July 21, 2020

**Re: Pedestrian Wind Conditions – Letter of Opinion
314-316 Batavia Place and 295-297 Albert Street
RWDI Reference No. 2004426**

Image 2 – Site Plan

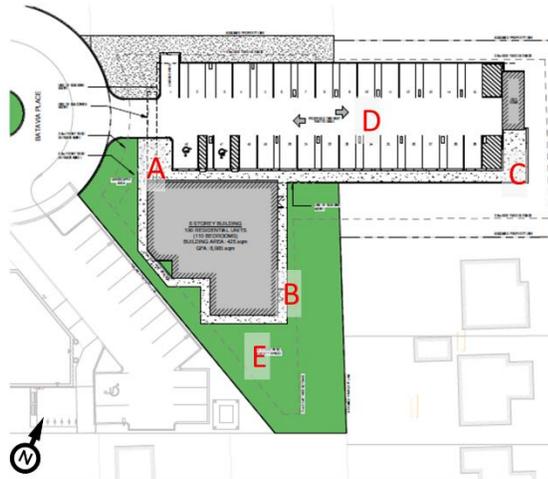
The main entrance is located near the building corner (see "A" in Image 2), where winds from the southwest through northwest can downwash from the building façade above and accelerate around this building corner. Also, the main entrance will be exposed to the strong northwesterly winds during winter. Wind conditions are predicted to be higher than desired for the main entrance. Installing a porous wind screen or planters on the west side of the entrance would be beneficial to improving wind conditions, the height of the wind screen or planters should be at least taller than the height of the entrance doors. In addition, recessing this entrance into the vestibule could also help improve pedestrian comfort.

Due to the westerly winds channeling through the parking area under the building, slightly higher wind speeds are expected at the Level 1 parking lot (see “D” in Image 2). However, since pedestrian using the parking lot will be active and less likely to remain in one area for prolonged periods of time, these wind conditions are considered acceptable.

The outdoor amenity space at grade level is located at the south side of the building (see location “E” in Image 2). In the summer, when the outdoor amenity space is expected to be used most frequently, the northwesterly winds are predicted to channel between the proposed building and the adjacent six-storey building (311-312 Batavia Place), as shown in Image 5. In addition, the easterly winds are also expected to accelerate around the southeast building corner. Due to the channeling winds and corner-acceleration winds, wind speeds at the outdoor amenity space are anticipated to be higher than desired for passive activities.
